# PRODUCT CHANGE NOTIFICATION

REVISED MAY 30, 2023

## Bourns® Model CDSOT23-SR208 Steering Diode Array and CDSOT23-SRV05-4 Steering Diode TVS Array Combo

### Addition of Manufacturing Site

#### Typical Part Marking

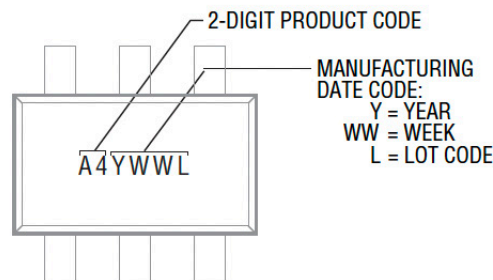
The Si fabrication and the assembly process will not change at this new additional assembly and test manufacturing site. The assembly process at the new site will change slightly because the interconnect material used at this new site will be changed from gold to copper, and the terminal finish will be changed from NiPdAu pre-plating to 100 % tin plating. These changes have been fully qualified and will have no impact on the fit or function of the affected part numbers. The part marking will be used to identify units produced at the new additional assembly and test manufacturing site. The lot code (L) of the new site will follow alphabetic characters while the current site will continue to use numbers.

The form of the part numbers made at the new additional manufacturing site will change due to the material changes described above and because of a small change in the part marking for traceability purposes. The quality, reliability and performance of the overvoltage protectors produced at the new manufacturing site will be the same as those from the existing plant. The production lead times of these overvoltage protectors should improve gradually as our capacity is expanded. The country of origin will remain the same.
